APPLICATION FOR PERMIT TO DRILL OR DEEPEN

Pork Chop Federal 27 #2E

**SUNDRY NOTICES AND REPORTS ON WELLS**  
*Do not use this form for proposals to drill or to re-enter an abandoned well. Use form 3160-3 (APD) for such proposals.*

WELL LOCATION AND ACREAGE DEDICATION PLAT

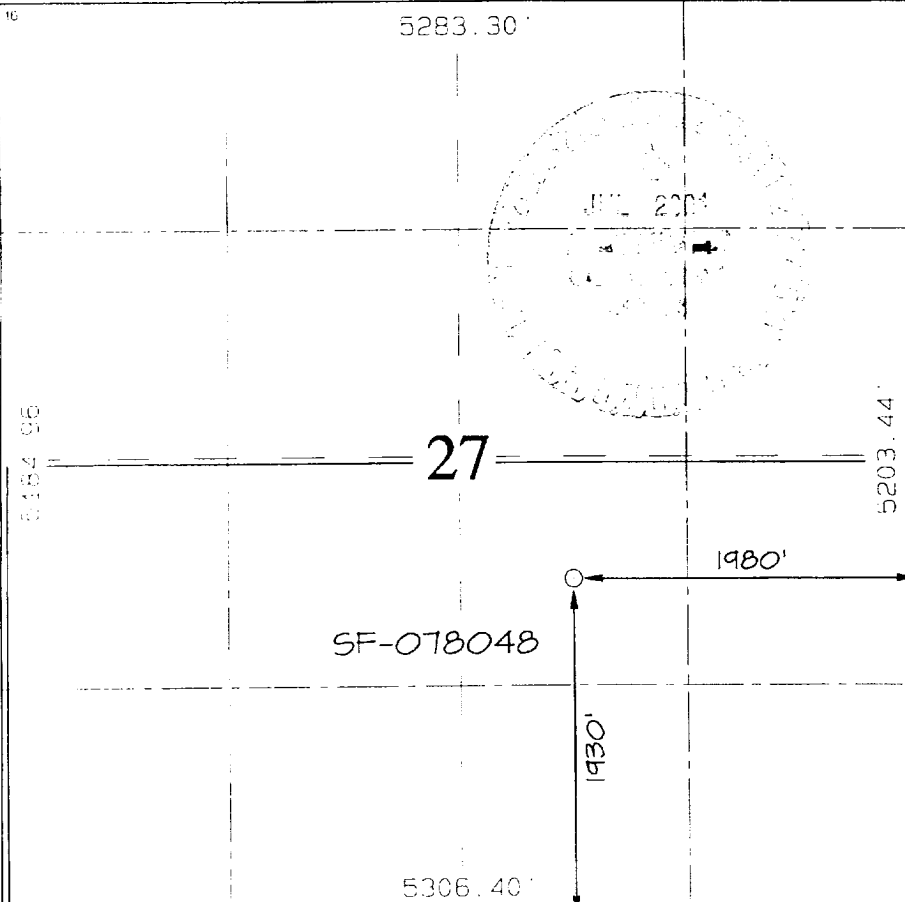
BLM requested that this location be moved from the originally staked footages.

Conoco Inc. requests authorization to relocate the originally submitted well location.

An APD was originally submitted on 3/16/01 at this location: 1330' FSL - 1675' FEL, Section 27, T26N, R7W

Newly requested staked location: 1930' FSL - 1980' FEL, Section 27, T26N, R7W
